NUMBER: 08-184-22

GROUP: 08 - Electrical

Flash: Telematics Box Module (TBM) Updates

2022 (WS) Grand Wagoneer/Wagoneer

Fig. 1
Error Message

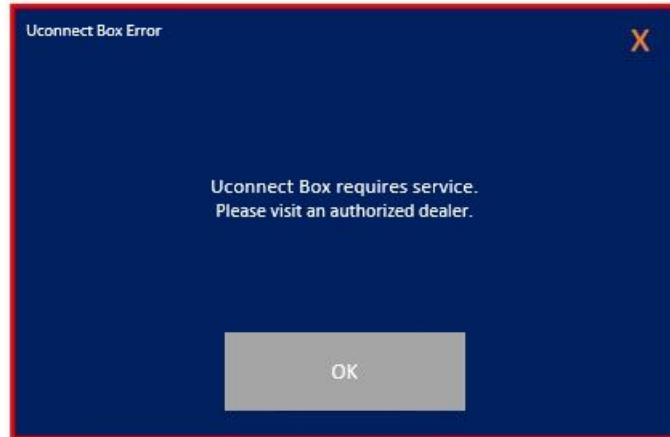
- ****Message displayed on the radio screen, "Uconnect Box requires service. Please visit an authorized dealer." (Fig. 1) , with no active or stored Diagnostic Trouble Codes (DTCs) set by TBM or Occupant Restraint Controller (ORC).**

NOTE: Uconnect box "requires service" message can be triggered by different reasons. For an issue on a new vehicle recently switched to customer mode, please follow the New Vehicle Preparation procedure to resolve Uconnect box require service message. Always fix TBM / ORC DTC issues first. If the issue could not be fixed, then reflash the TBM software.
